ENZO

Important Safety Notice

Concerning all Enzos manufactured between 01.11.2011 and 26.03.2012.

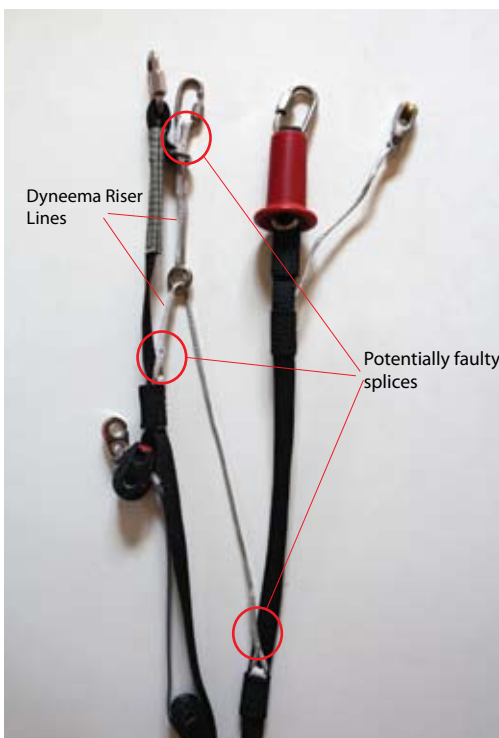
The potentially effected parts are the two grey coloured Dyneema lines attached to the risers, one connects to the main A and B risers and the other joins this to make up the rest of the outer A riser. It has been found on some risers that the splices of these lines are too short.

A faulty splice looks like this:
The inner core is too short in the stitching.

Contact your Ozone dealer who will issue you with a Replacement Riser Line Kit that must be correctly mounted before further use.

IMPORTANT: You must not fly your wing with faulty risers, there is a risk of structural failure. The Dyneema Riser Lines must be replaced before flying your wing again.
